**Agenda Item 3  
Veterans Park  
Monument**

## STAFF REPORT AND RECOMMENDATION

TO:	Chairman Grinnell and members of the Historic Preservation Commission
DATE:	September 28, 2022
FROM:	Jennifer Baehr, Planner Catherine Czerniak, Director of Community Development
SUBJECT:	<b>Veterans Park Memorial Monument – Continued Consideration</b>

TO:	Chairman Grinnell and members of the Historic Preservation Commission
DATE:	September 28, 2022
FROM:	Jennifer Baehr, Planner
SUBJECT:	<b>Continued Consideration - 695 N. Western Avenue, Chalet Nursery Signage</b>

**PREVIOUS SUBMITTAL – AUGUST 2022**

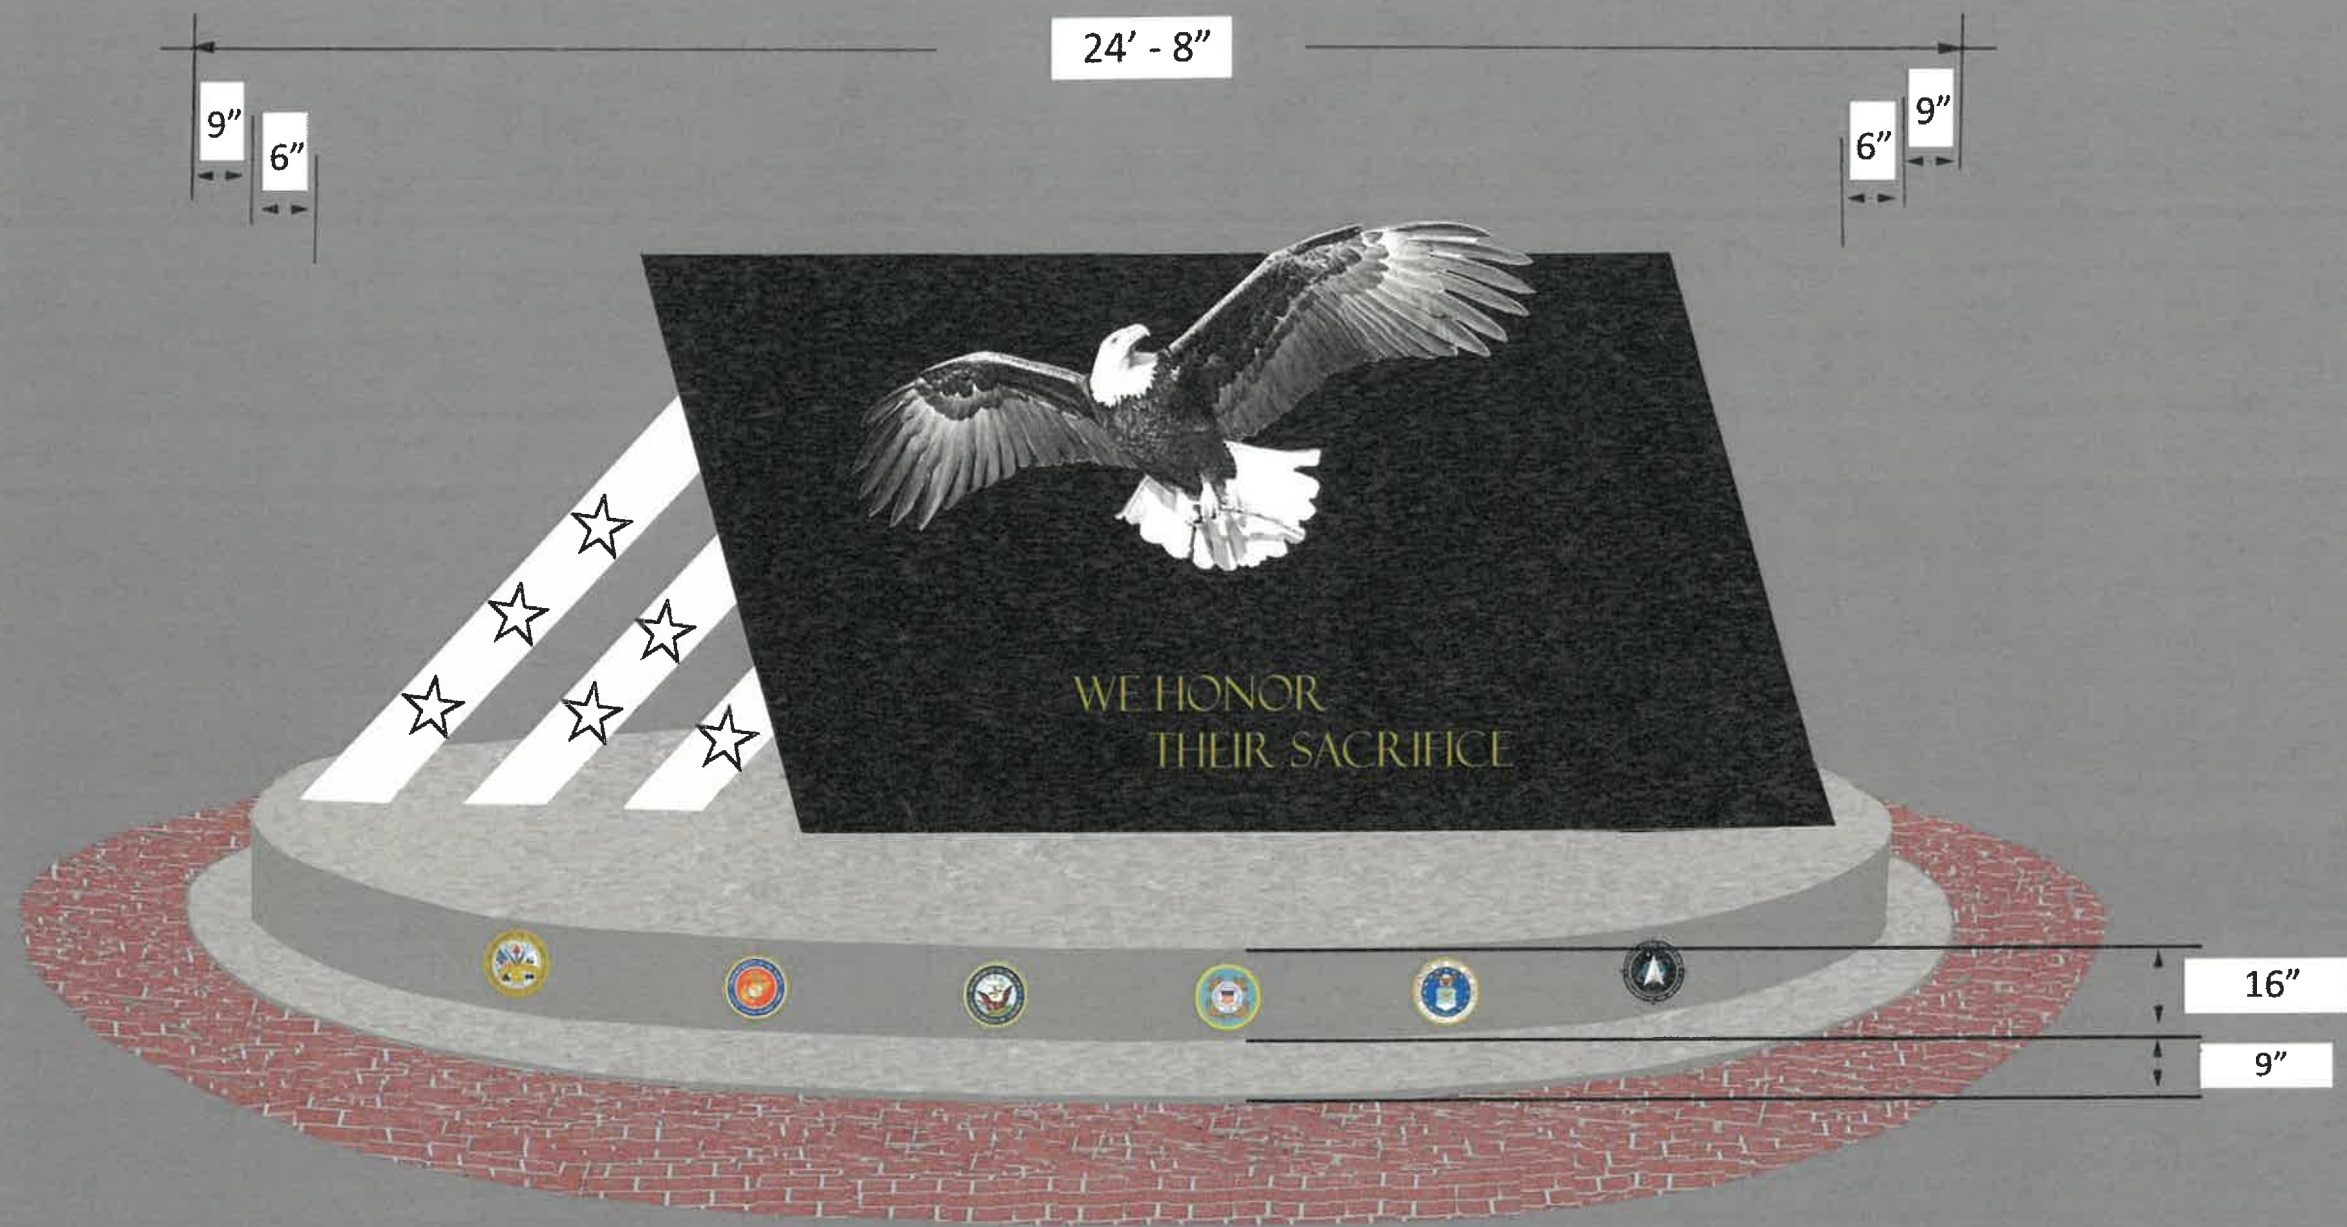
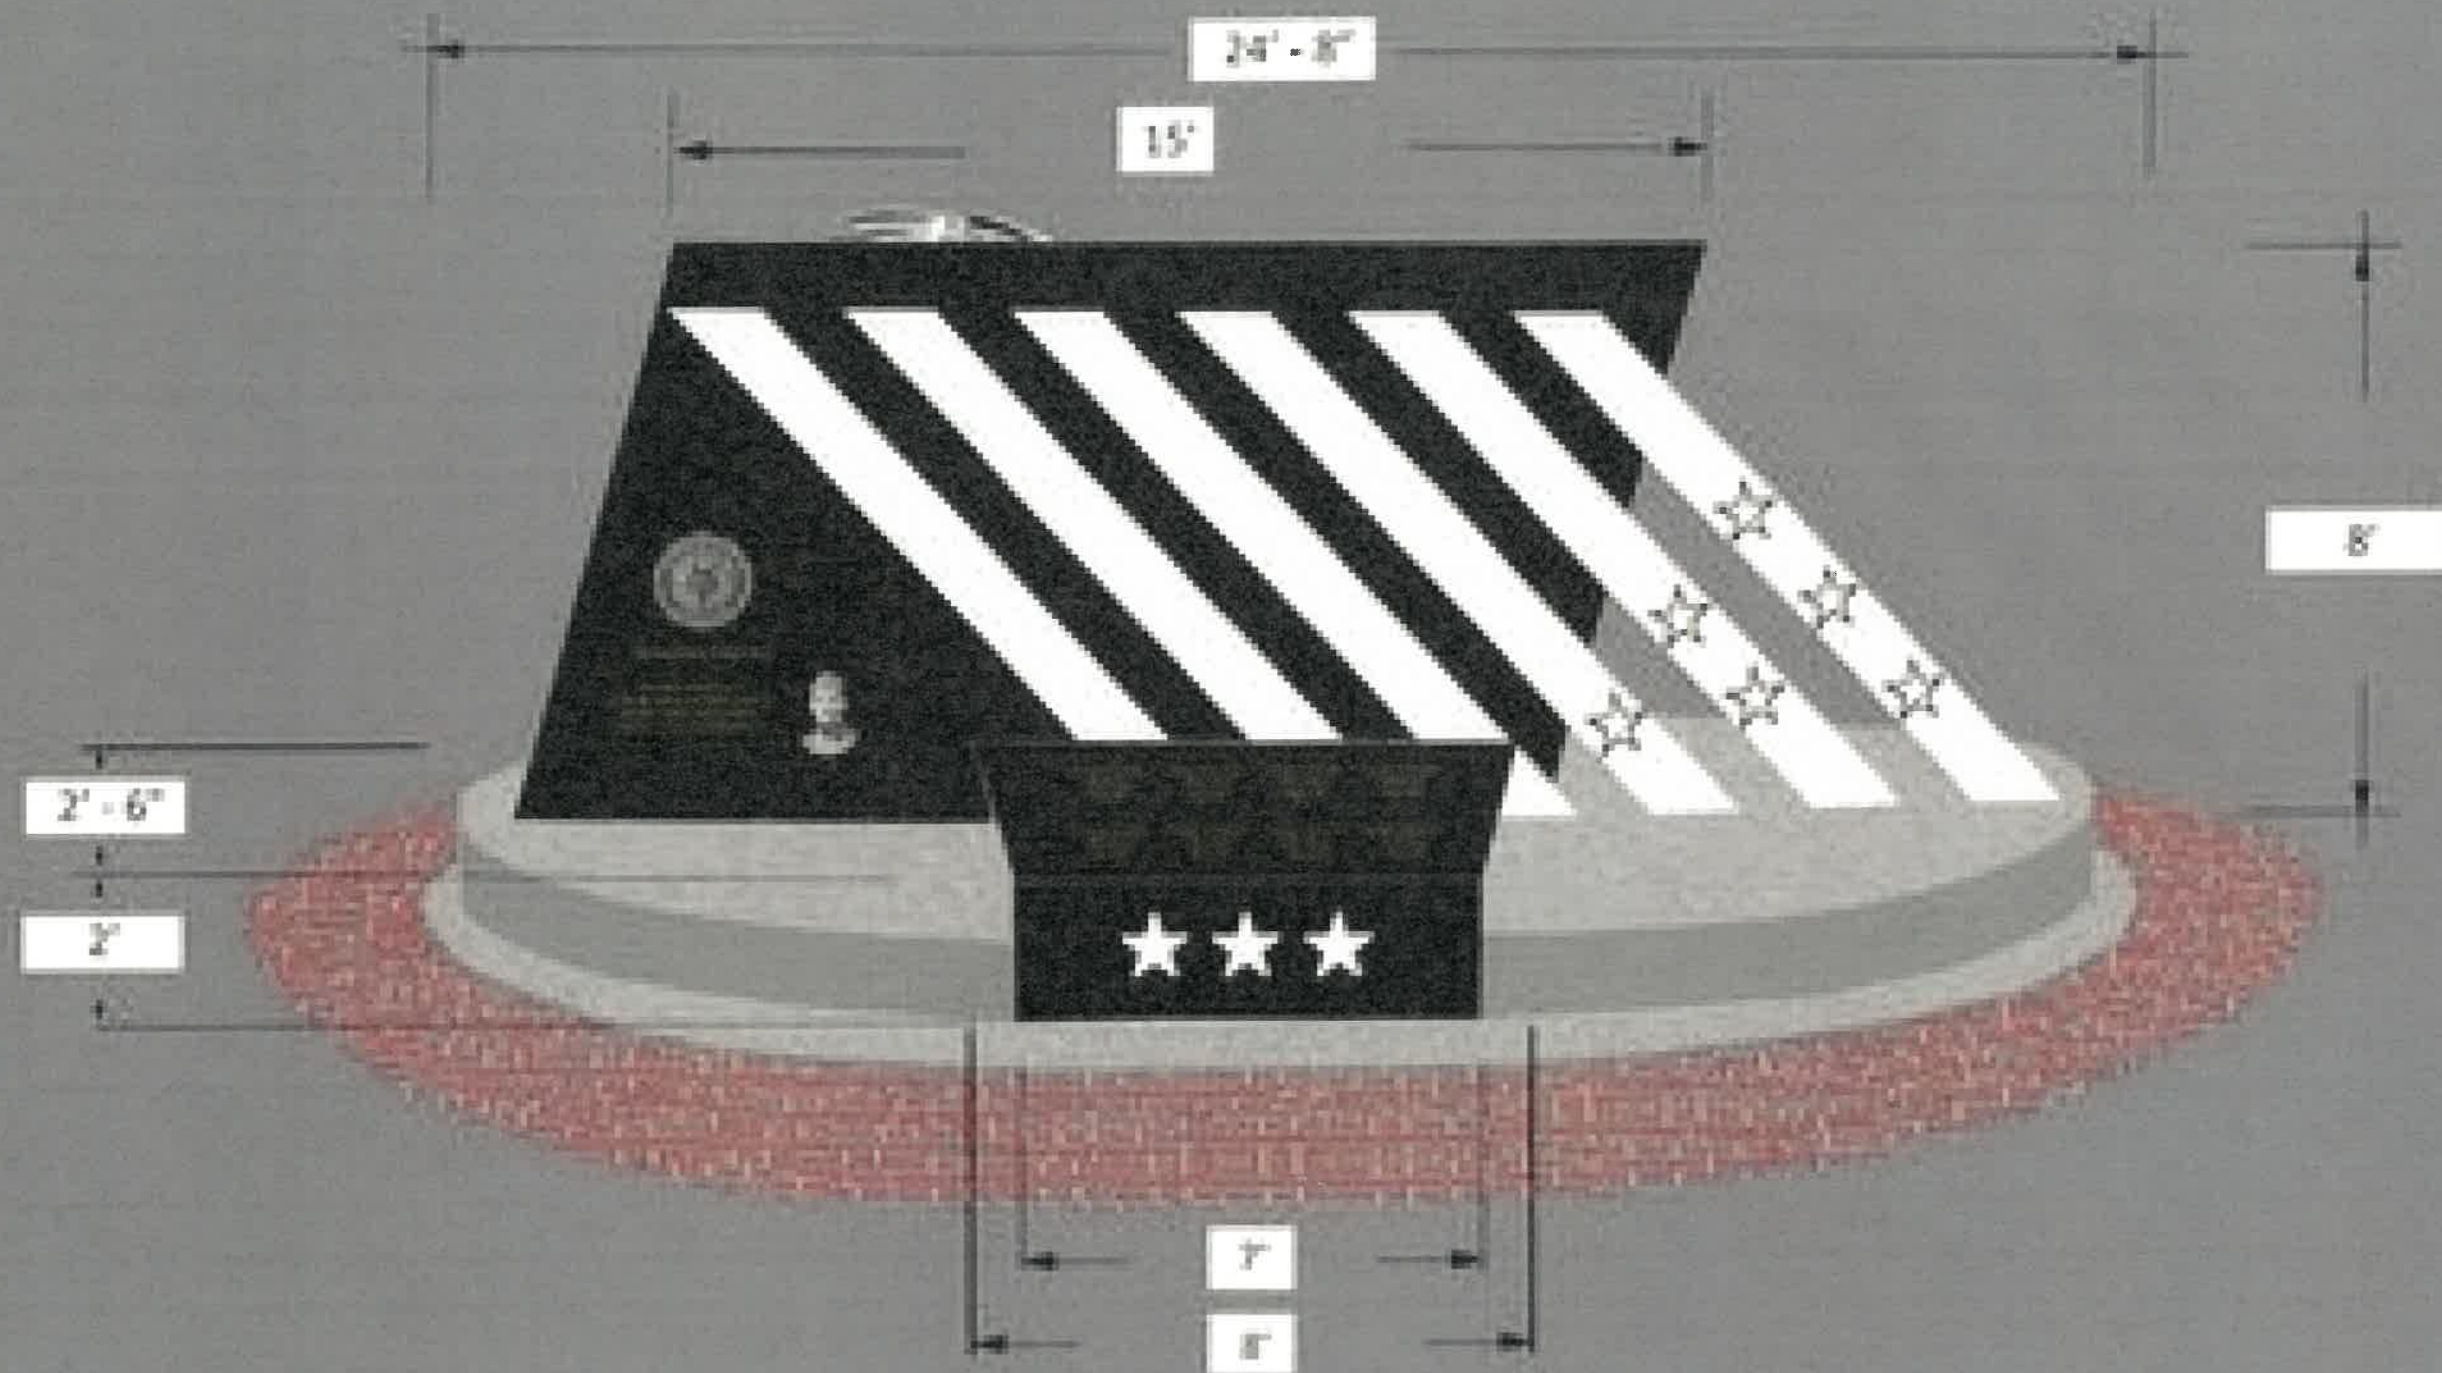
- The shape of the monument was changed from a parallelogram to a rectangle.

- The granite is a variegated black with a polished surface.
- The gold lettering on the front of the monument is now proposed to be incised into the granite slab and will appear white.

- The stainless-steel elements, the stripes, on the back of the granite slab were eliminated. These elements were intended to represent the stripes in the flag. The petitioners responded to the comments that this element added a contemporary feel to the monument, out of character with the historic district.

- The plaques that represent the seals of each branch of the military services previously proposed on the front, west site, of the monument's base are now proposed on the back of the monument base, facing the seat wall.

- The plaques on the monument base that were previously proposed in various colors are now proposed in silver.

# PREMIUM CAST "S" POST SYSTEM - ALUMINUM

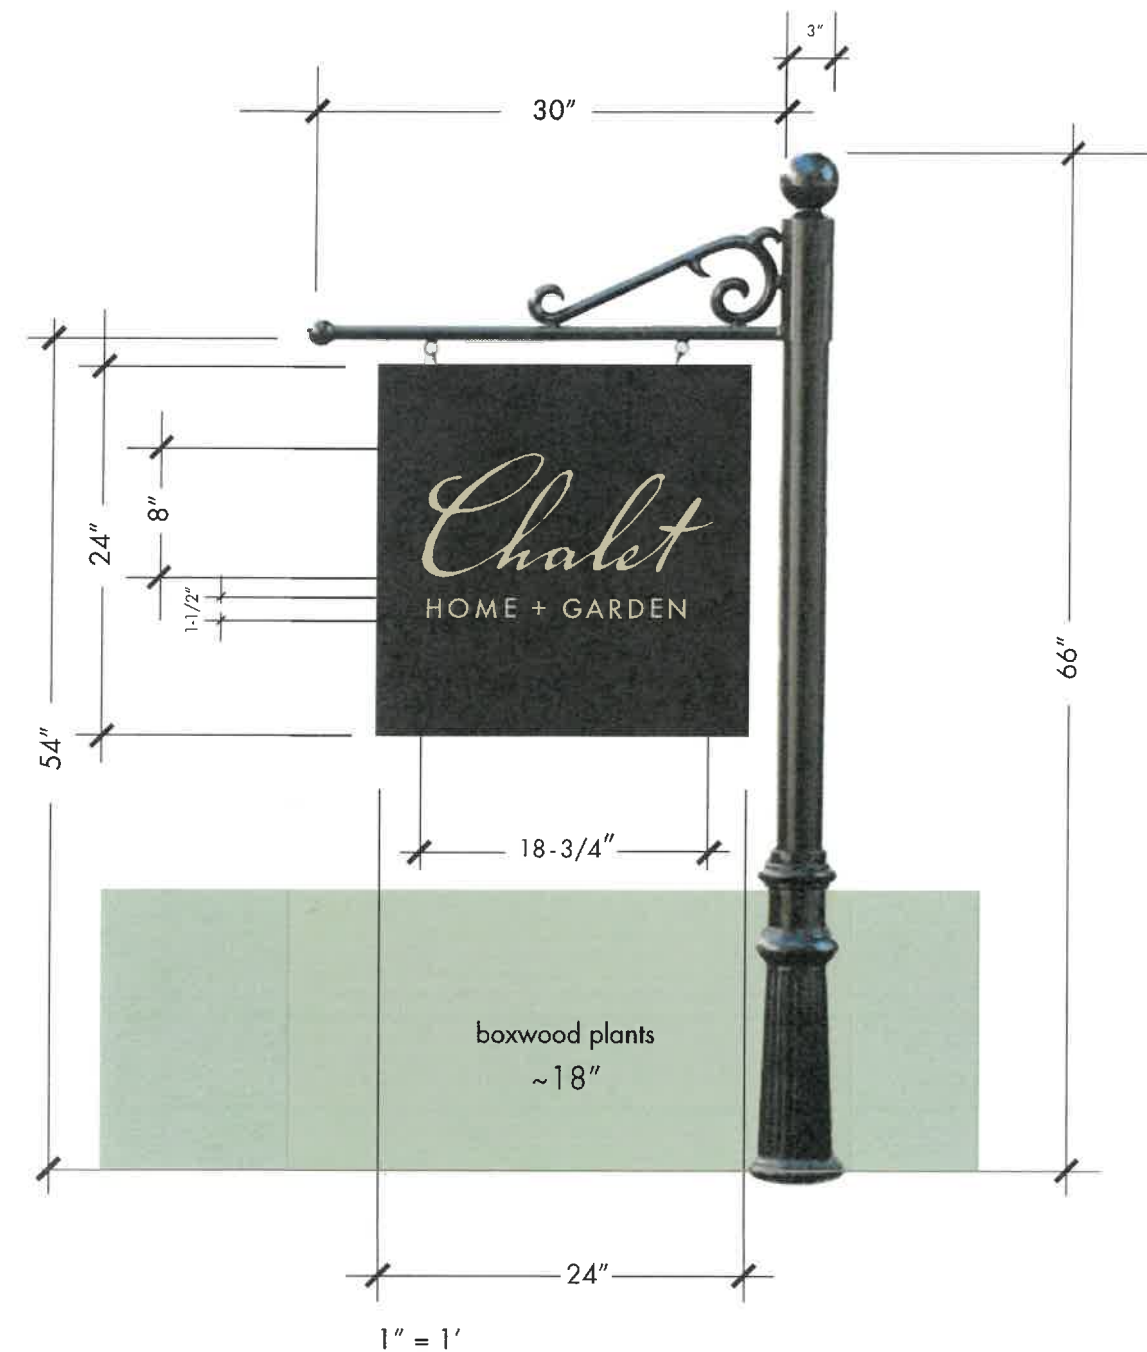
2. Consider softening the post sign.

See new post design which has a softer shape including a scroll element that supports the horizontal arm

**PREVIOUS SUBMITTAL – JULY 2022**

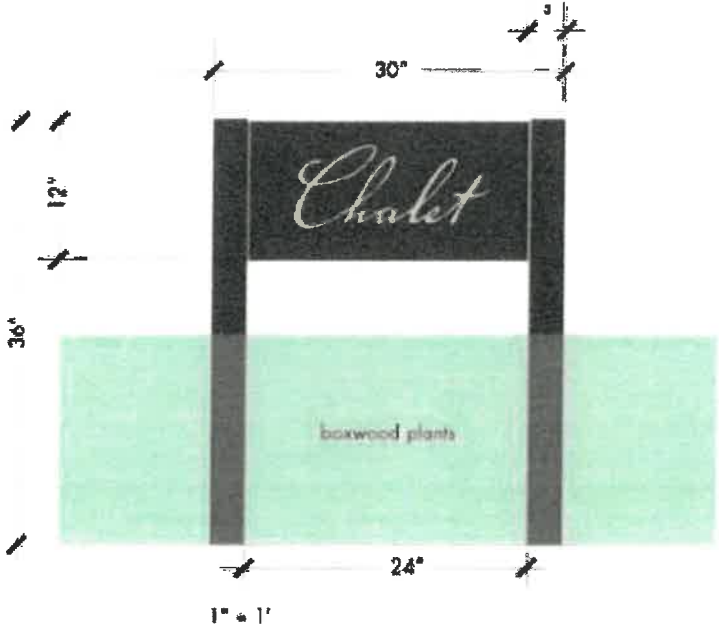
- Consider alternate materials (wood) and colors.
- Consider softening the appearance of the freestanding post sign.
- Consider adding a description of the business.
- Retain the perpendicular position of the freestanding sign.
- Consider window signage on the entrance door.
- Eliminate the sign over the transom window.

6. Consider removal of the sign over the transom window.

- The hanging sign above the west facing entrance was eliminated. A window sign is now proposed on the west facing entrance door.
- The freestanding sign was refined to reflect a softer appearance more in keeping with character of the surrounding area.
- A description of the business was added to the proposed window and freestanding signs.

We have removed it.

Title:  
PROPOSED  
West Elevation

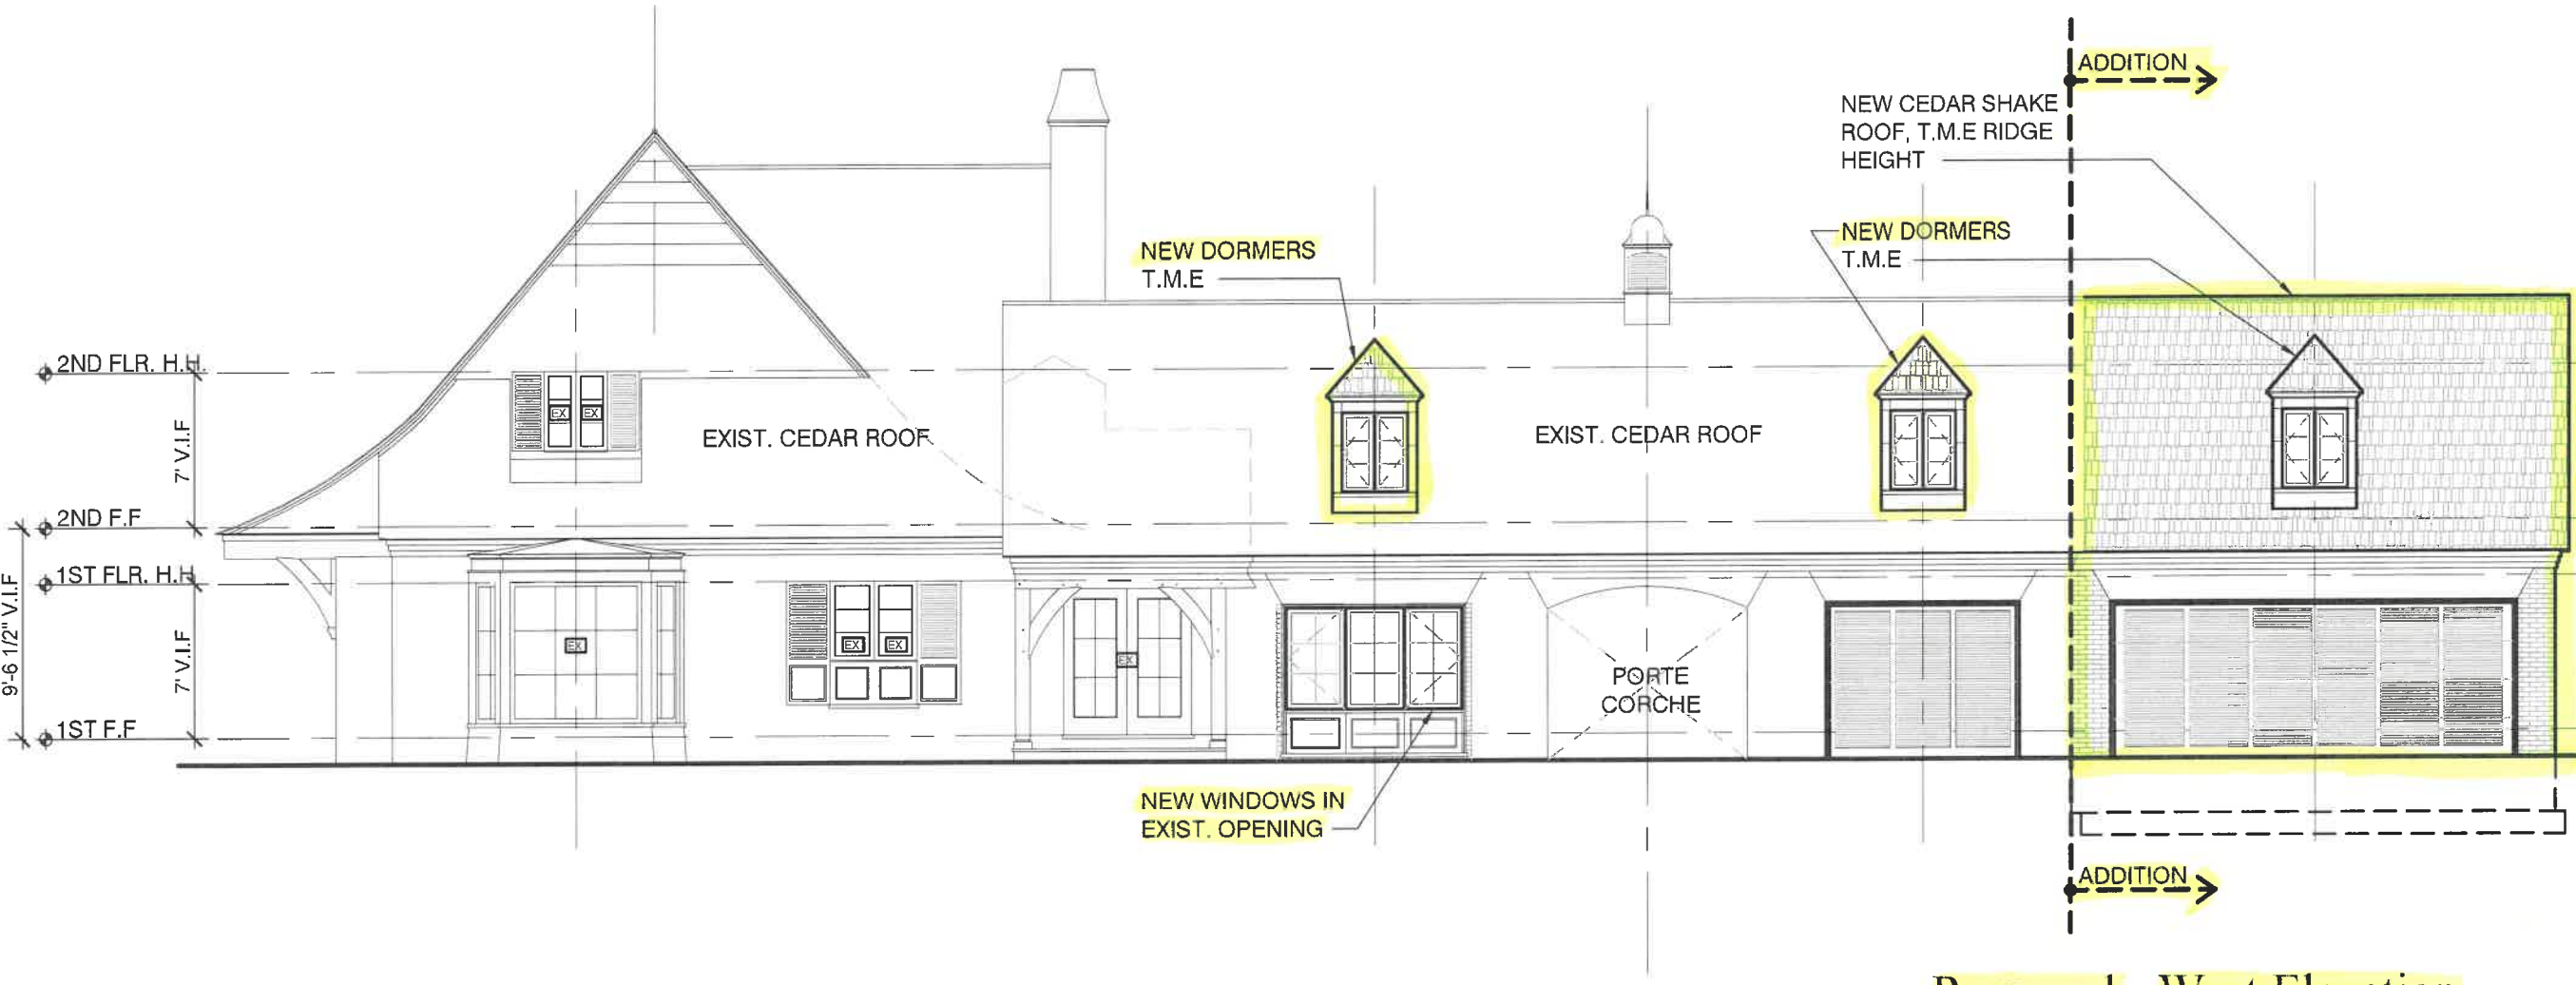
This standard is generally met. The openings on the addition mostly follow the proportions of the openings on the existing home. The existing casement style openings on the home only have horizontal muntins and the triple casement window proposed to replace the existing garage door opening in the breakfast room has vertical and horizontal muntins. Consideration should be given to eliminating the vertical muntins to more closely match the appearance of the existing windows on the home.
